## Response to DRC Resolution from the meeting held June 2, 2016

THAT the Design Review Committee recommends **RESUBMISSION** of the Duplex Development at 103 – 105 Glengarry Crescent that addresses the following items:

**DUPLEX HOMES**  
**103/105 GLENGARRY CRESCENT**  
**WEST VANCOUVER**  
for  
**BEHRANG OMIIDVAR**

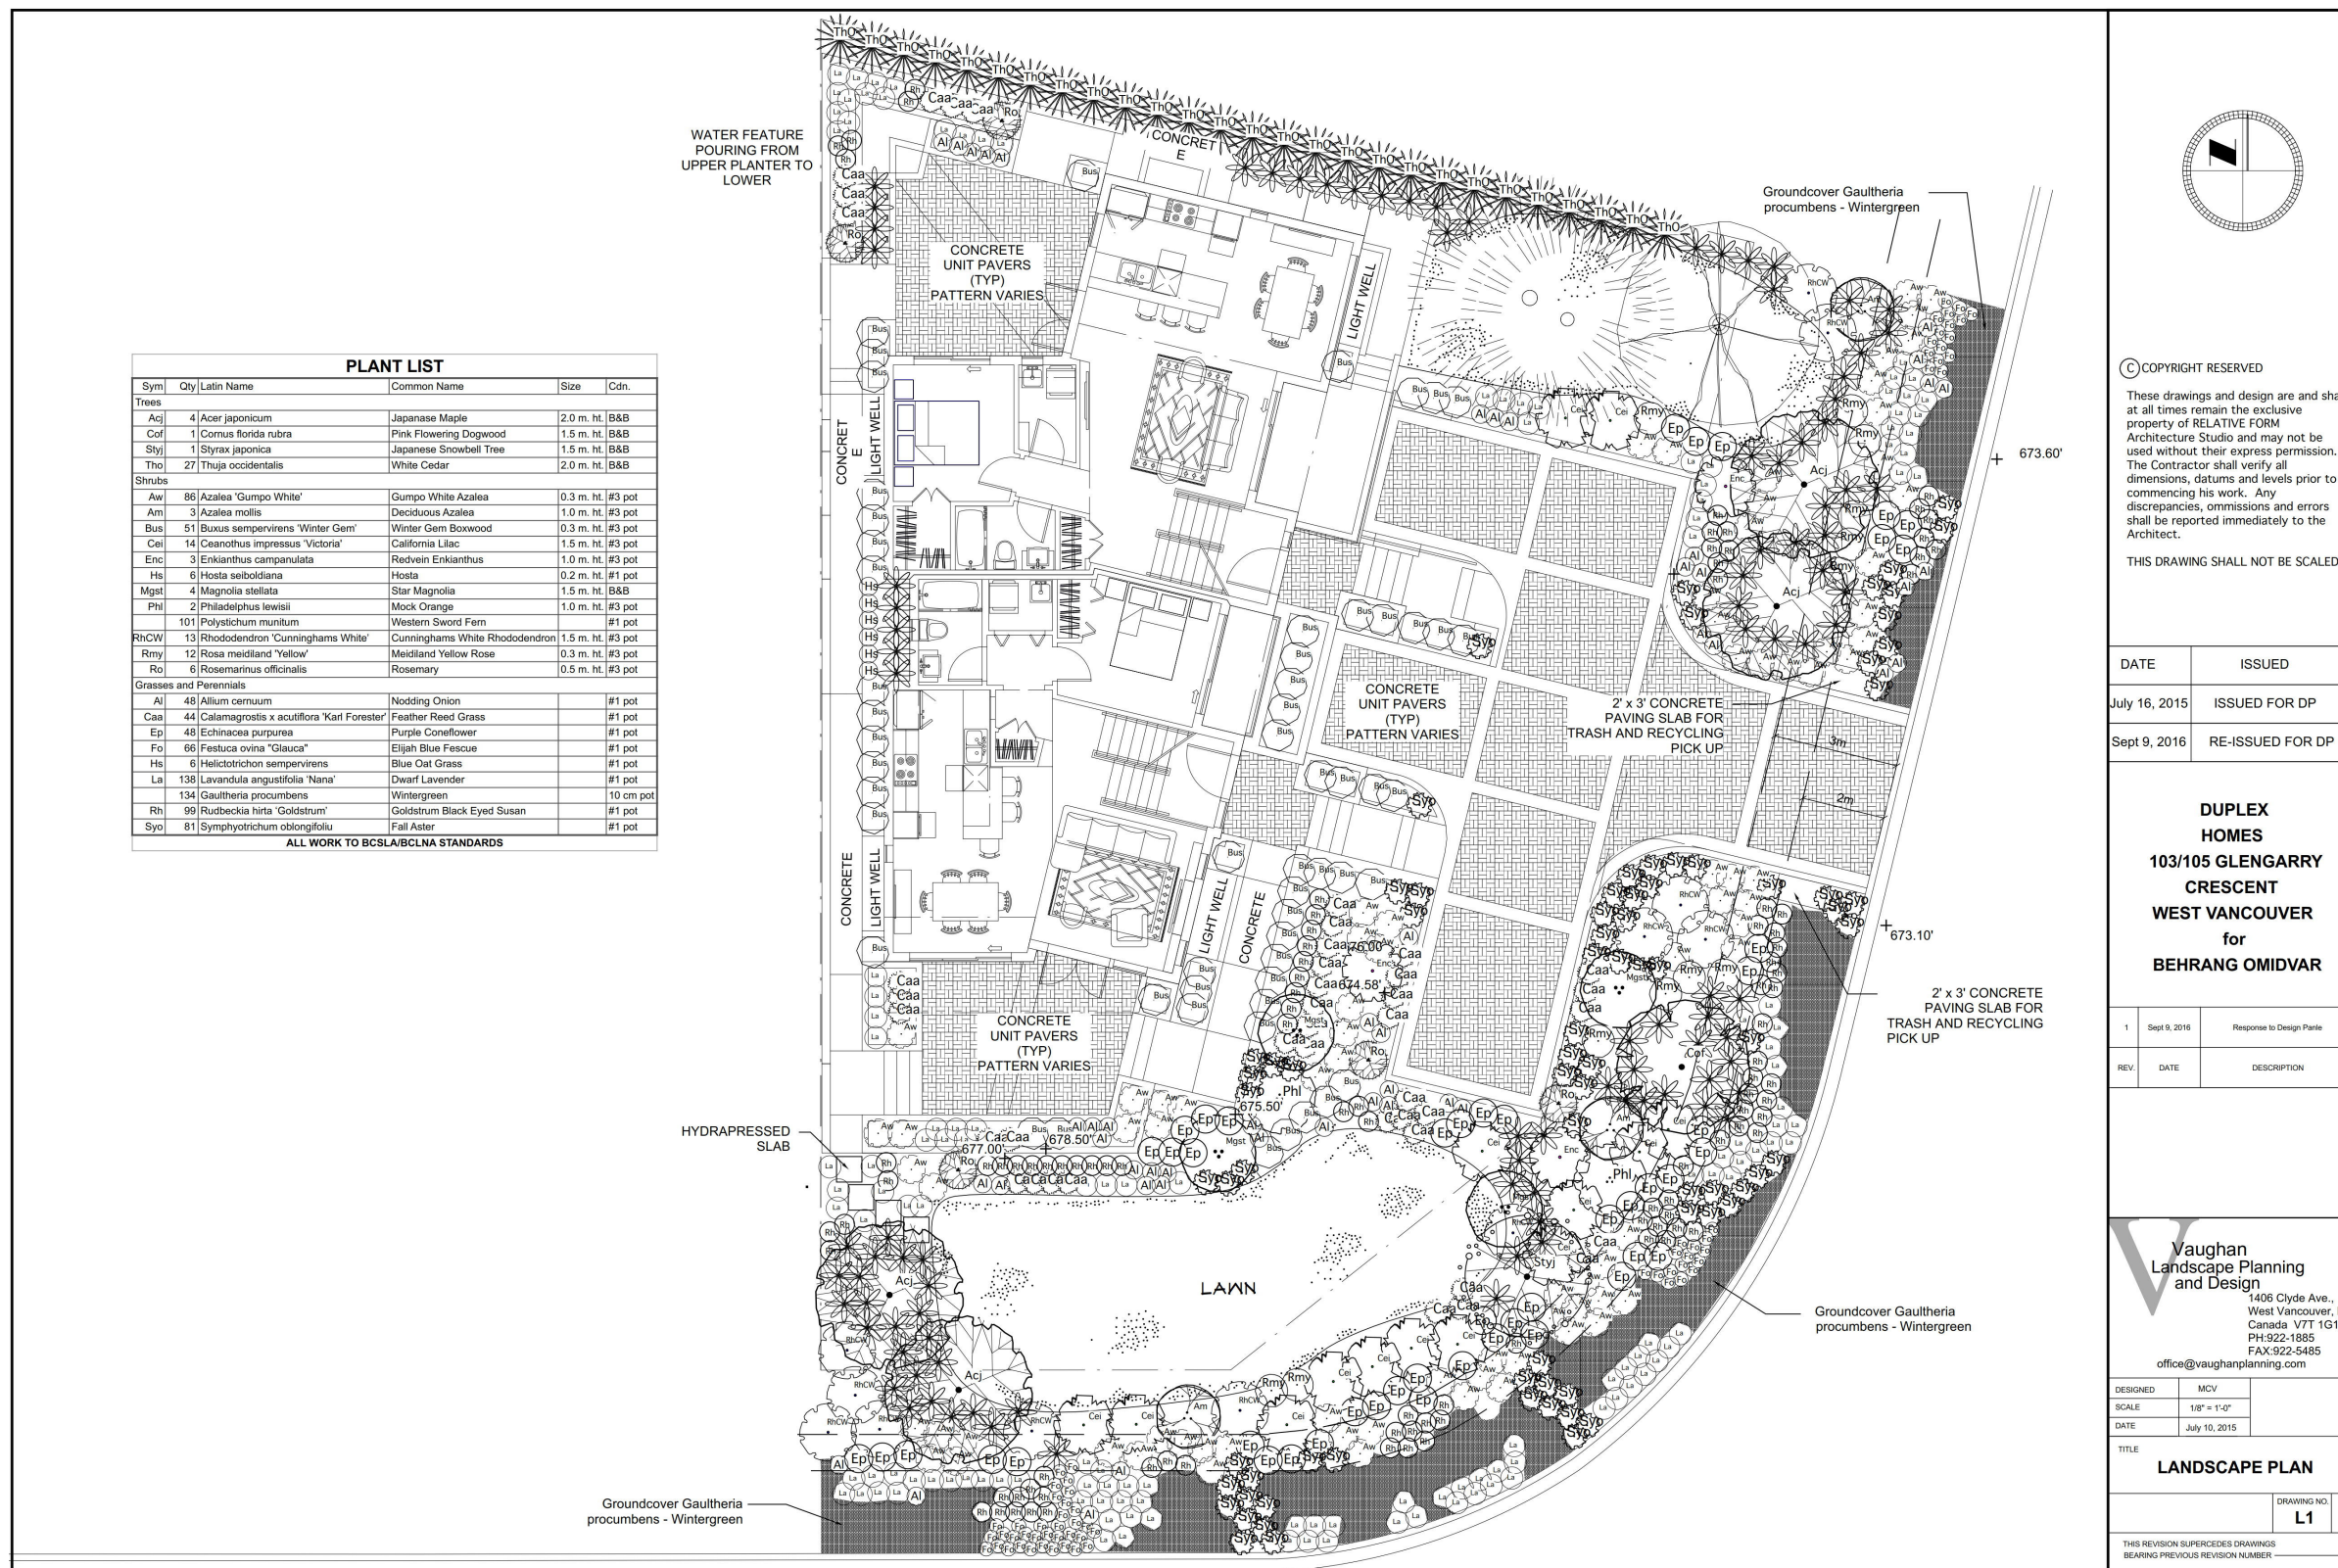
### 4. examine an appropriate location for garbage and recycling curbside

Consistent with the practice in the neighbourhood, garbage and recycling will be picked up from the end of the driveway at the curb. Concrete pads have been provided on either side of the driveway to accommodate this.

*Image 3: North Elevation*

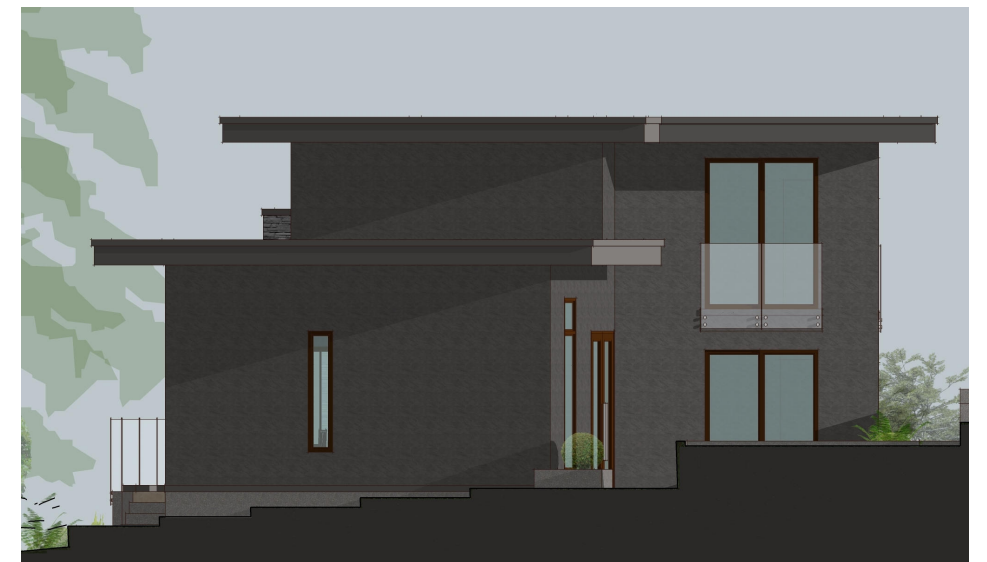
### 1. reduce the complexity of the building Form

We have reduced the number of materials to two primary cladding materials: stucco and stone. Wood is used as an accent material for doors, windows, soffits and glass is used for railings and canopies; The roof expression has been simplified as suggested by DRC by having all flat roofs. Fenestration has been simplified both in shape and detail with fewer unique elements and no muntin bars. The entry stairs have also been simplified and softened and both pedestrian walkways have been removed to create a clear and simplified arrival sequence from the street, via the paved driveway to a simplified front door, whose sidelights have been removed to allow for more stone facing giving a stronger statement of entry to each unit.
